**DMH&D**  
 — DRIVER MCAFEE —  
 HAWTHORNE · DIEBENOW

### Staff Report

### Staff Report – Renew Arlington Design Review (RADR) Staff Comments

Figure 11 - Conceptual image of site layout and massing in Catalyst Character Area

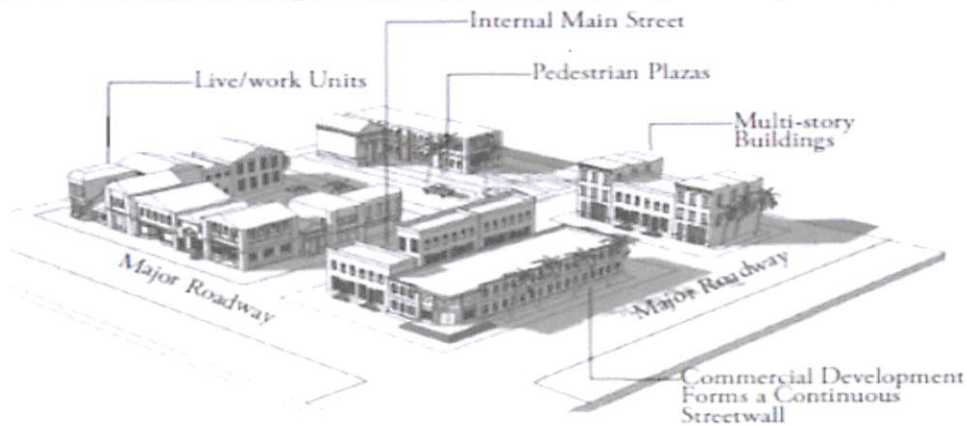
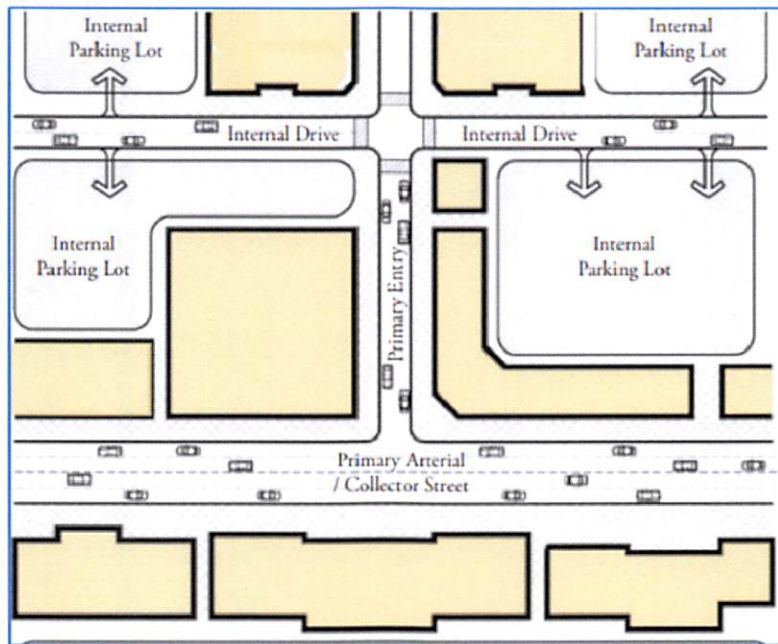
- **ISSUE 2 on Page 3, ¶1** – PUD is not consistent with intent or design guidelines of the Renew Arlington Zoning Overlay Catalyst Area based on Figures 11 and 12.
  - PUD meets this requirement.

- Figure 11 and Figure 12 are Conceptual images
- There are multiple ways to meet the intent of this requirement

- 2 buildings front Merrill Road, a minor arterial, similar to Figures 11 & 12
- Parking lots are interior to property
- **ISSUE 3 on Page 3, ¶1** – The PUD does not propose mixed use that is vertically or horizontally integrated
